**Brookhaven National Laboratory
Plant Engineering - E&CS Division
Engineering Change Notice Form**

PROJECT: CCWF II

ECN Title: Trane Chiller Remote Starter

ECN No. 56

G1

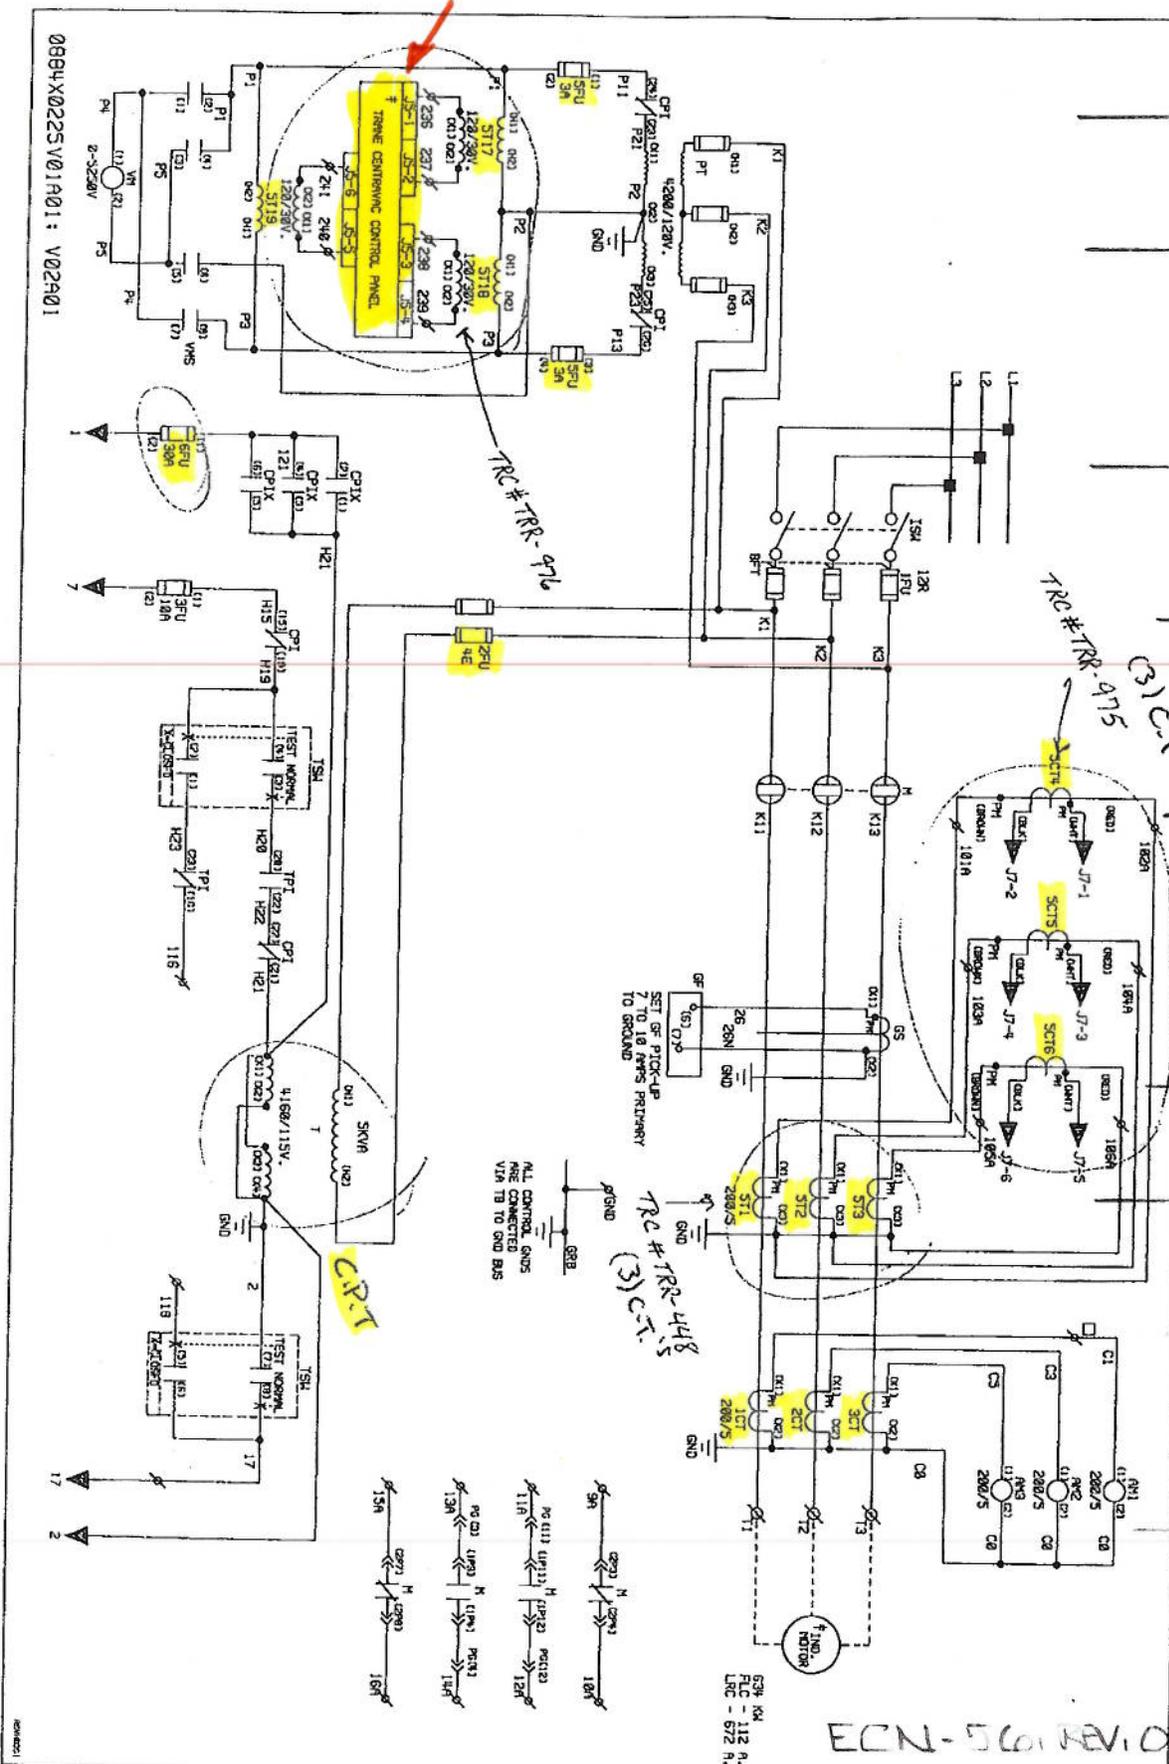
| Description of Work | Drawing Reference Line/ Notes |
|---|---|
| Provide/ install replacement CPT: 5kVA, 4160VAC x 115VAC, | G1, Line 56-4 |
| Provide/ install replacement 2FU fuses with 5E for replacement CPT, | G1, Line 56-3 |
| EC to provide/ install relays CPIX, 5K11 and 5kVA control power transformer (CPT) as a replacement for existing 2kVA CPT. | G2, Lines 56-33, 56-34, 56-31; G1, Line 56-4, respectively. |

G2

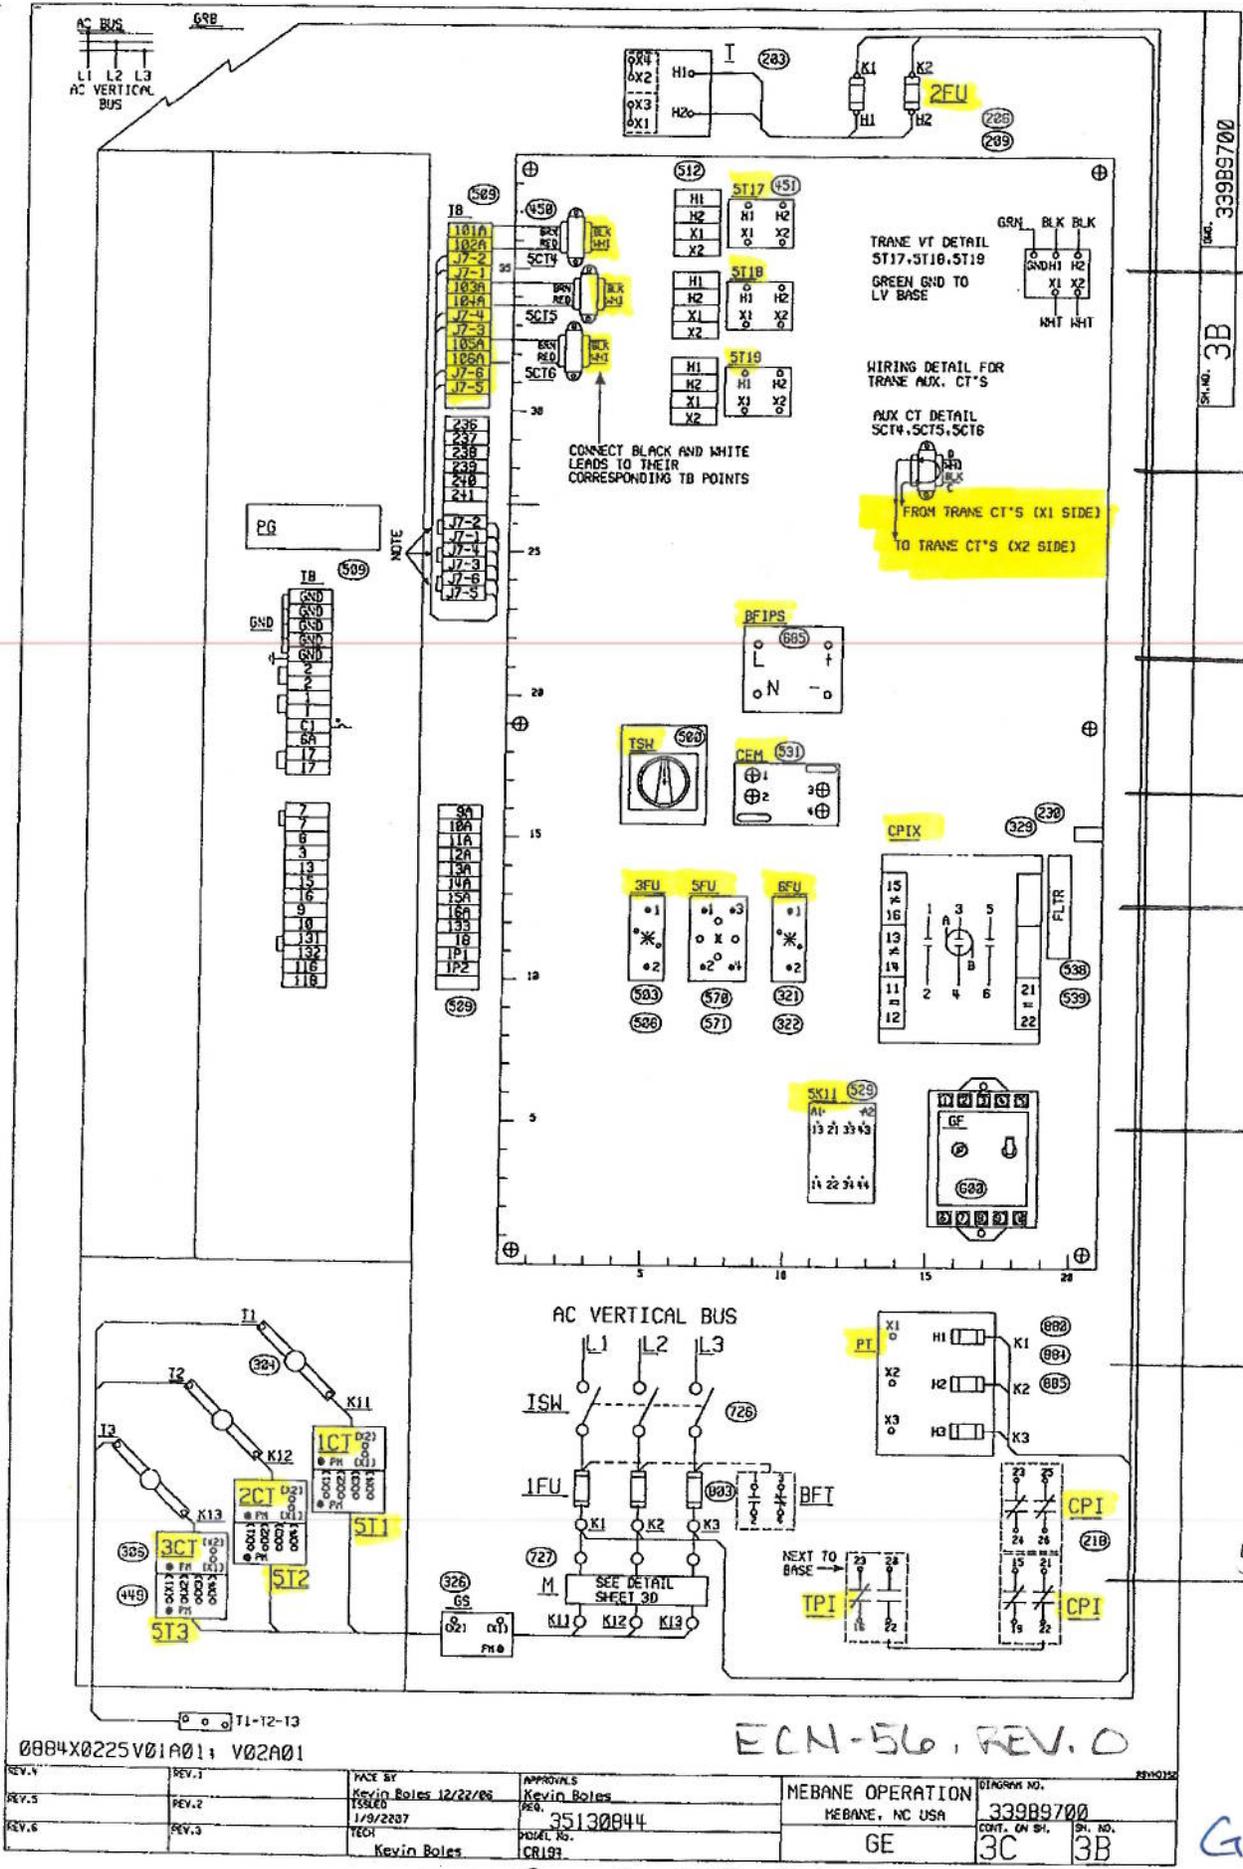
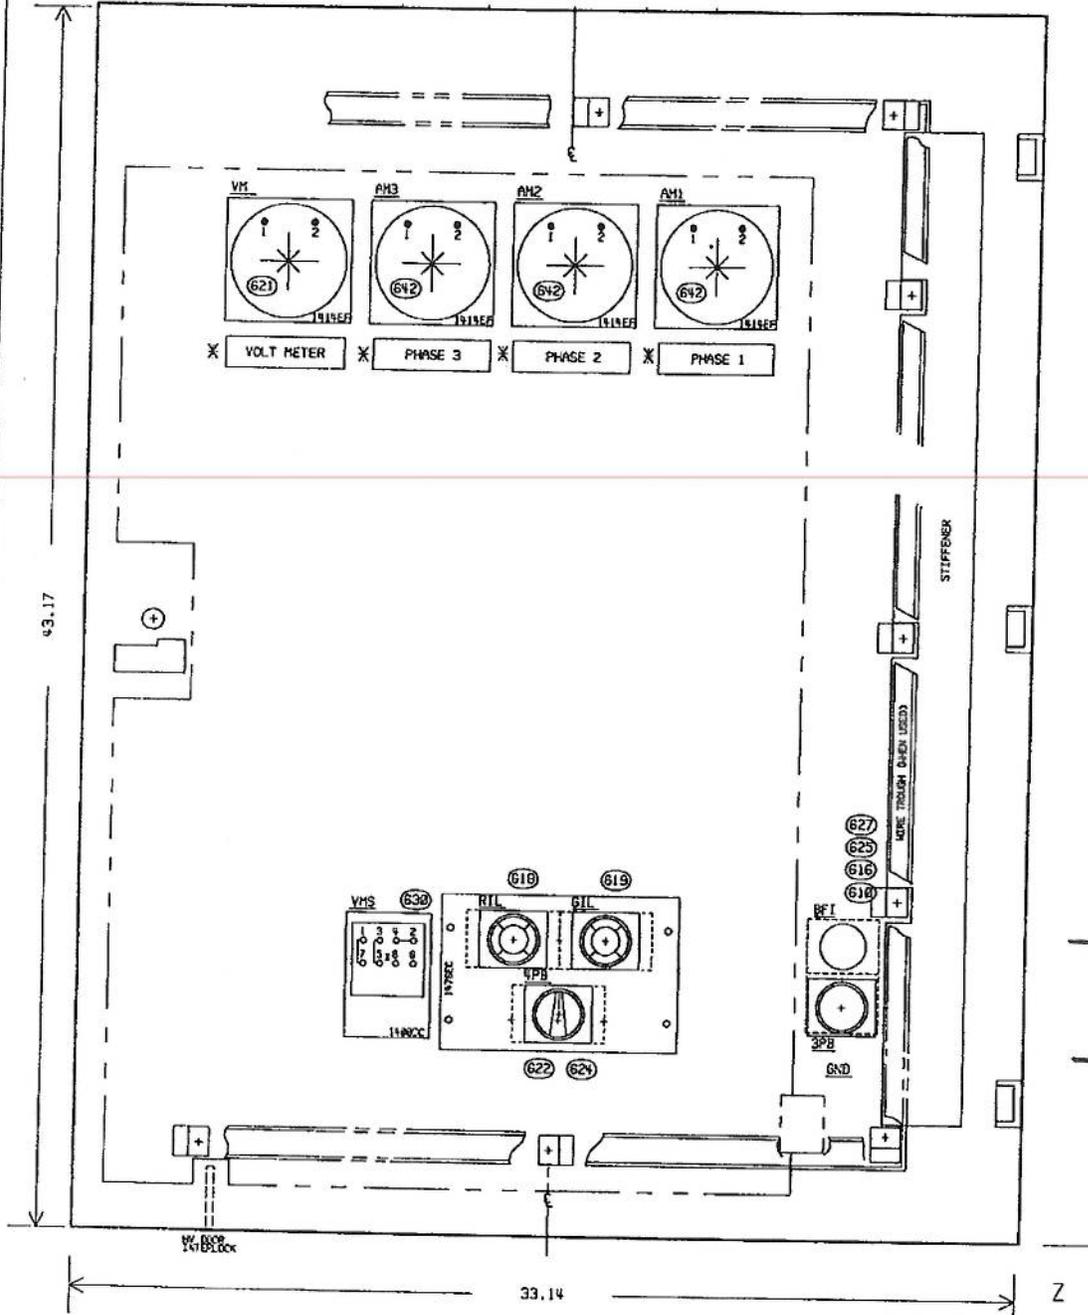
| Description of Work | Drawing Reference Line/ Notes |
|---|---|
| EC to provide/ install 5T1, 5T2, and 5T3, primary CT's; Trane P/N TRC #TRR-448 "doughnut" style CT devices on feeder cables. | G2, Line 56-21 NOTE- Verify POLARITY and MATCH PHASE w/ 4kV feeders. |
| Provide/ install 5CT4, 54CT4, and 5CT4, secondary CT's; Trane P/N TRC #TRR-975. EC to mount secondary CT's on back plate. | G2, Line 56-19, 56-20 |
| Provide/ install 6-point Shorting Terminal Block for terminating CT's. | G2, Line 56-29 |
| Provide/ install PT's 5T17, 18, 19, secondary PT's; mount on back plate, | G2, Line 56-16 |
| Provide/ install 12-point terminal block for terminating PT's and other control wiring, (NOTE- there are open terminal points.) | G2, Line 56-29 (G1, Line 56-9) |
| Provide/ install 120V control circuitry between Trane C/P and GE Starter Cabinet, | G2, Line56-17, 56-22 |
| Provide/ install 30A J-Type fuse (6FU) for 120V control circuitry to Trane C/P | G2, Line56-17 |
| Provide/ install relay 5K11, then wire as shown in Group 2 field sketches, | G2, Line 56-23, 56-26 |
| Provide/ install relay CPIX, then wire as shown in Group 2 field sketches, | G2, Line 56-25 |
